City of Surrey
PLANNING & DEVELOPMENT REPORT

File: 7917-0283-00

Planning Report Date: June 25, 2018

PRELIMINARY LOT LAYOUT
 SUBDIVISION AT 6080-172 STREET, SURREY, BC

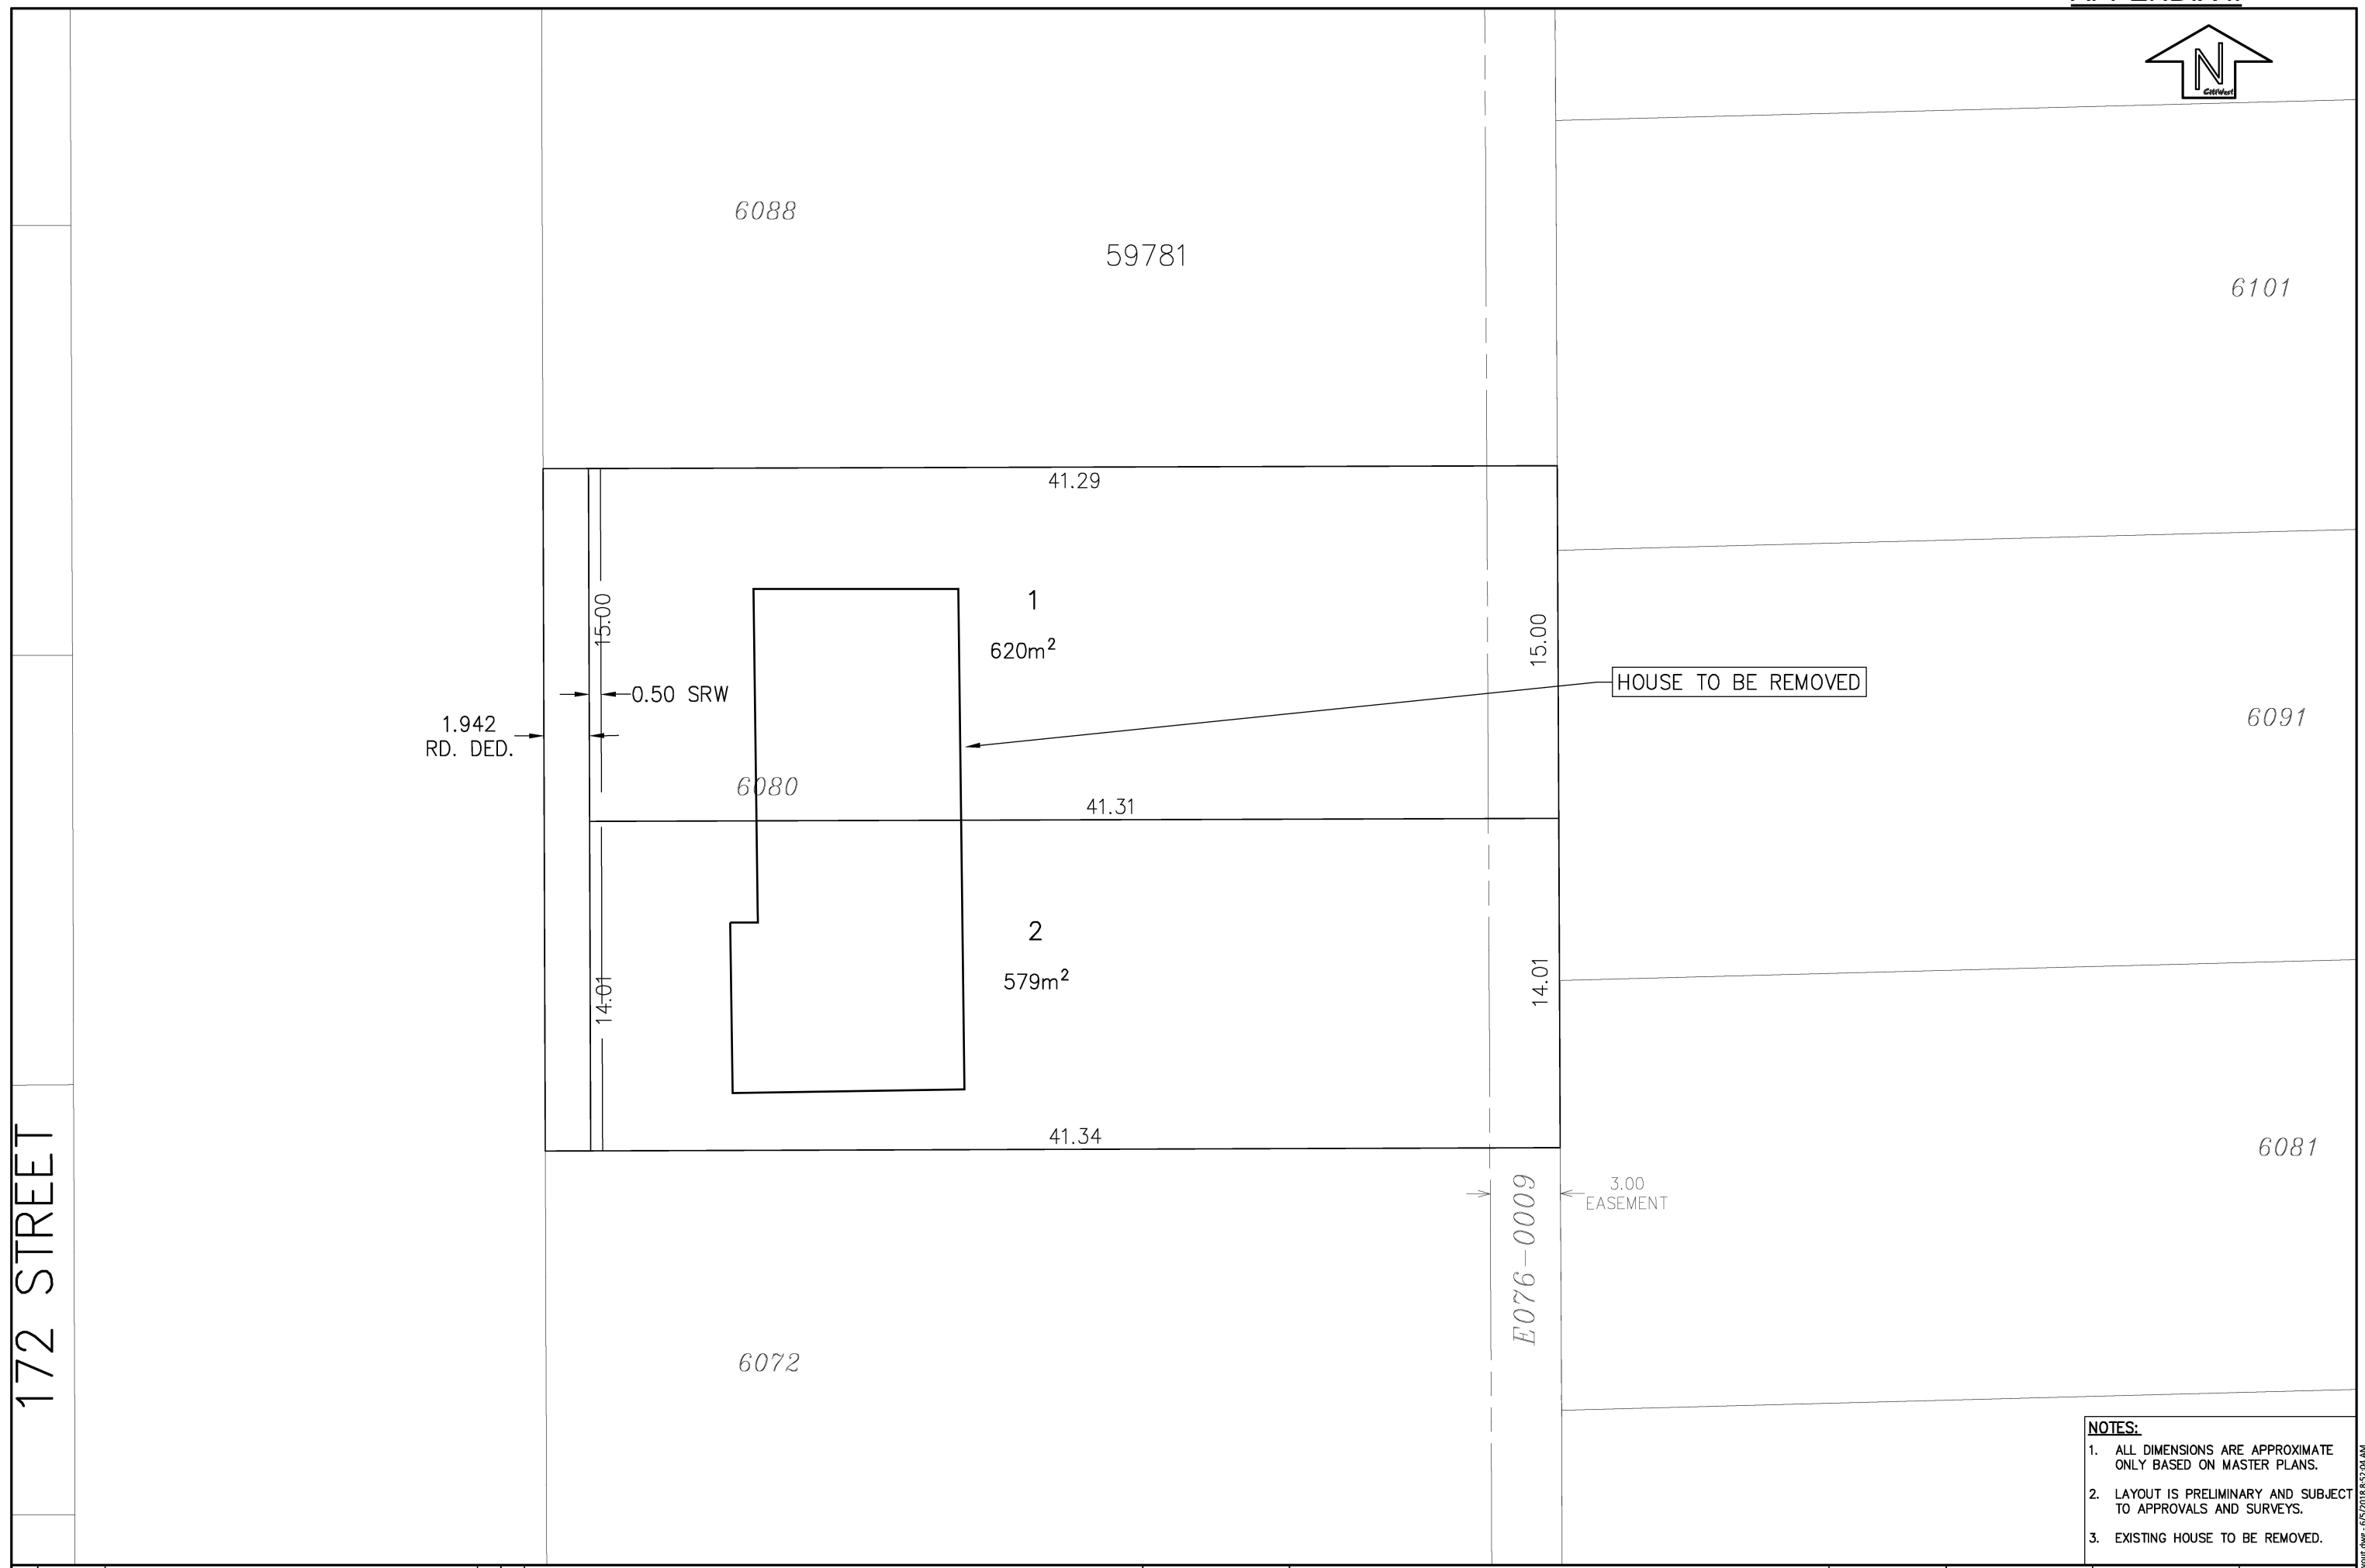
- The Single Family Residential (RF) Zone requires a minimum lot width of 15 metres (50 ft.). The Applicant is proposing a variance to reduce the minimum lot width of proposed Lot 2 to 14 metres (46 ft.) to allow for subdivision into two (2) single family residential lots.

- At 14.0 metres (46 ft.) in width and 41.3 metres (136 ft.) in depth, proposed Lot 2 requires a Development Variance Permit for reduced lot width.

- A preliminary lot grading plan submitted by the applicant's consultant has been reviewed by staff and found to be generally acceptable. Basements are proposed on both lots. This requires 0.3-0.5 metre (1.0-1.6 ft.) high retaining walls to meet with the grade elevations of the north and south abutting properties.

- The applicant has worked to address the abutting north property (6088 172 Street) owners' concerns regarding the proposed retaining wall. This retaining wall will be offset from the property line to protect a row of existing shared cedar hedges which the neighbour wishes to maintain for privacy. Where the arborist has recommended removal of hedges in poor condition, the applicant has proposed re-planting of new hedges.

(The applicant has revised their proposed lot grading plan to accommodate the existing row of shared cedar hedges in the backyard by offsetting the proposed retaining wall. The applicant has proposed to replant hedges where the arborist has recommended removal due to poor condition).

PRELIMINARY LOT LAYOUT
 SUBDIVISION AT 6080-172 STREET, SURREY, BC

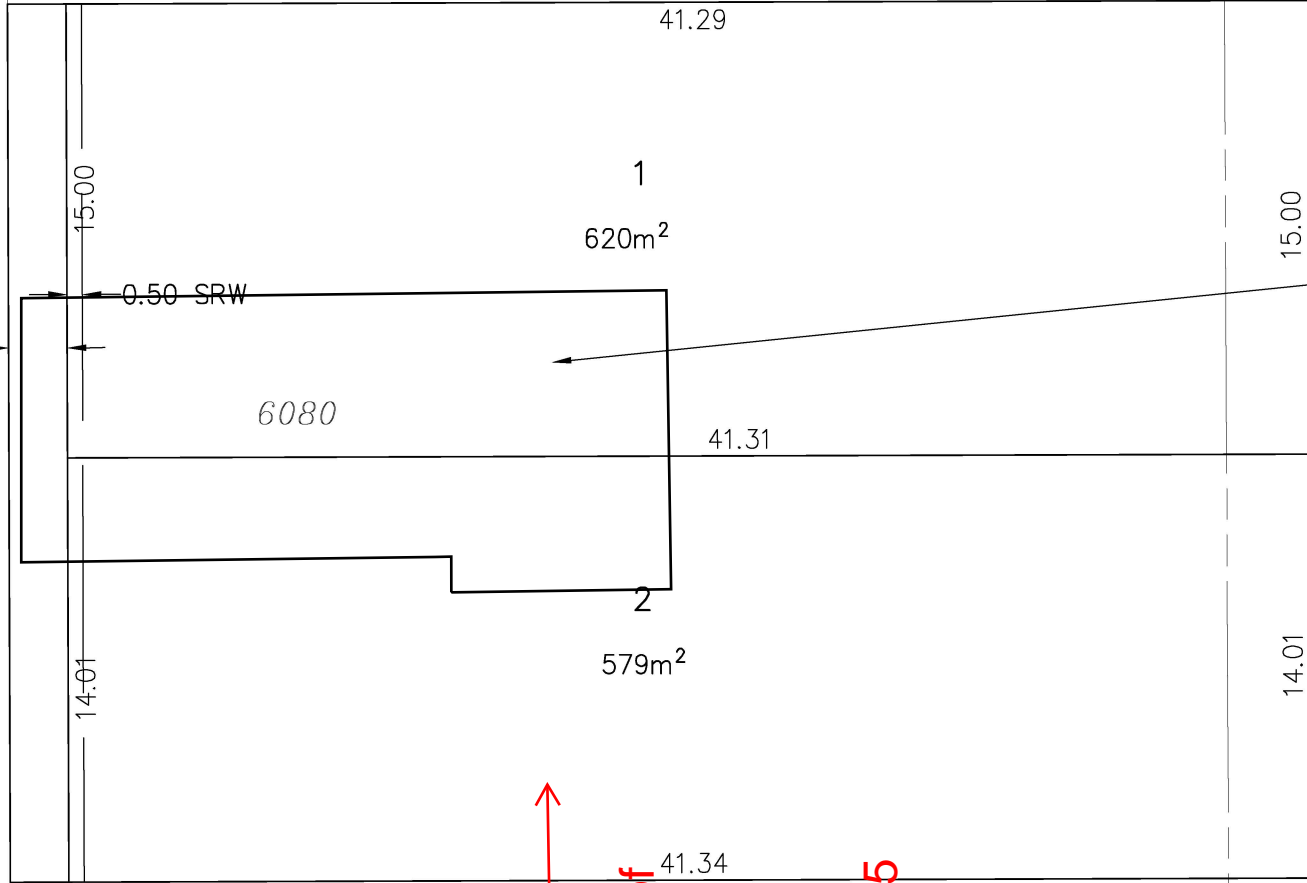
The minimum lot width of
the Single Family
Residential (RF) Zone is
varied from 15.0 metres
(50 ft.) to 14.0 metres (45
ft.) for proposed Lot 2.
